**B.O.A**  
C15-2019-0055  
2803 Edgewater Dr.

Subject: Mark Odum Plans for 2803 Edgewater Drive

2803 EDGEWATER C I 5-2019-0055 INTERESTED PARTY SUGGESTIONS – JAN 13, 2020

Rough sketch of sample “Stilt House”

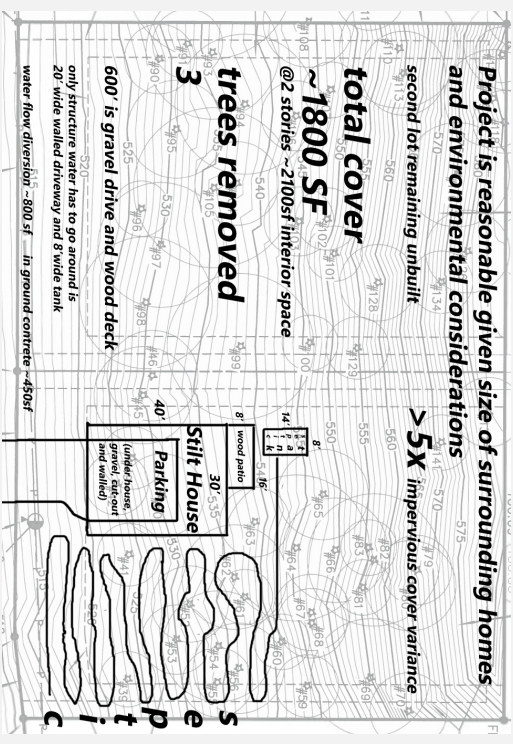
We would propose an alternative development model of a “stilt house” with a pier and beam foundation, a minimal impervious footprint, and a gravity-fed septic system.

Advantages of “stilt” construction – flexibility of placement on slopes, less need to alter and grade the land, less need to damage or remove trees, and greatly simplified drainage requirements.
